PRODUCT CHANGE NOTIFICATION

VARISTORS

Bourns® Model MOV-07D, MOV-10D, MOV-14D and MOV-20D Series Metal Oxide Varistors *Product Taping Method and Machinery Change*

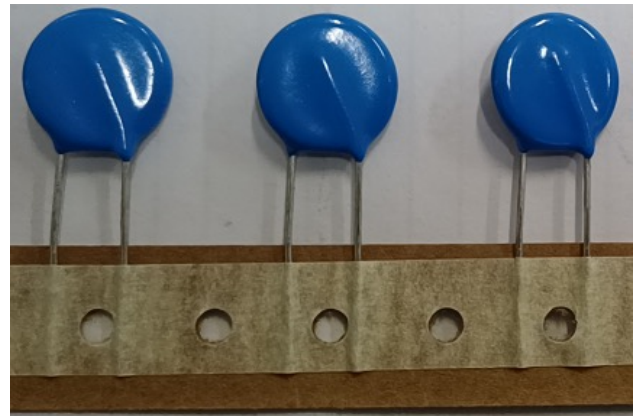
Riverside, California – May 19, 2023 – Effective August 1, 2023, Bourns will begin using a new taping machine and product taping method to improve production efficiency for the [Model MOV-07D](#), [MOV-10D](#), [MOV-14D](#) and [MOV-20D](#) Series Metal Oxide Varistors. As shown below, the new taping machine and method will cover the lead terminals at the bottom of the tape. Specific information and figures are provided at the end of this Product Change Notification.
